$\cdots$ South-East Elevation ELEVATIONS BOLAN-AAM-BA-ZZ-DP-AR-07201 hummun SCALE 1 : 200 @A1 1 : XXX @A3

Bollo Lane : Plot 3A

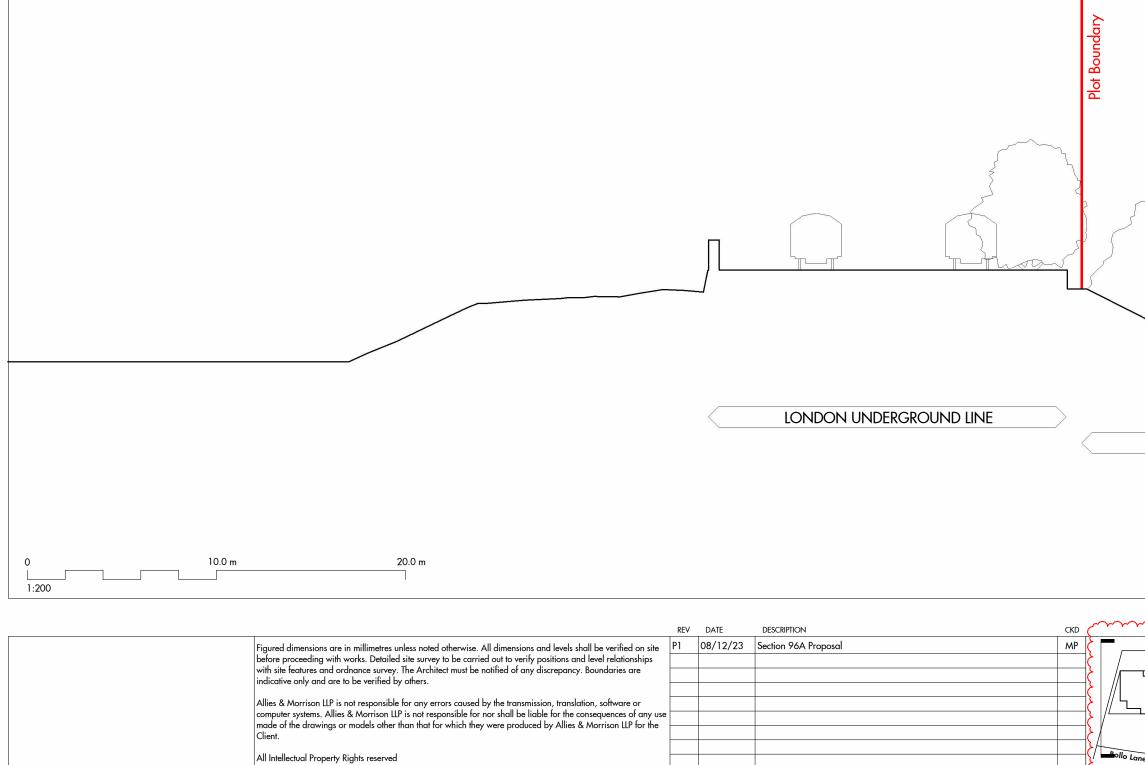
- 1.02 Residential Accommodation: Amendments to the tower and podium floorplate to accommodate the increased area of the dual stair core whilst achieving minimum Nationally Described Space Standards (NDSS) to residential homes;
- 1.07 Residential Accommodation: Amendments to the building height to achieve thermal perfomance and level access to external amenities.
- 2.01 Plant Accommodation: Amendments to the location, quantum and sizing of building plant and servicing required.
- 2.03 Building Servicing: Amendments to the provision and location of cycle parking.
- 4.03 Facade: Amendments to the external finishes and materials -Masonry infill panel.
- 6.01 Amendments to the Drawing title and number. Please refer to Document issue register.
- 6.08 Amendments to the Elevation and Sectin view alignments.

$\sim$ (6.08) hunnin
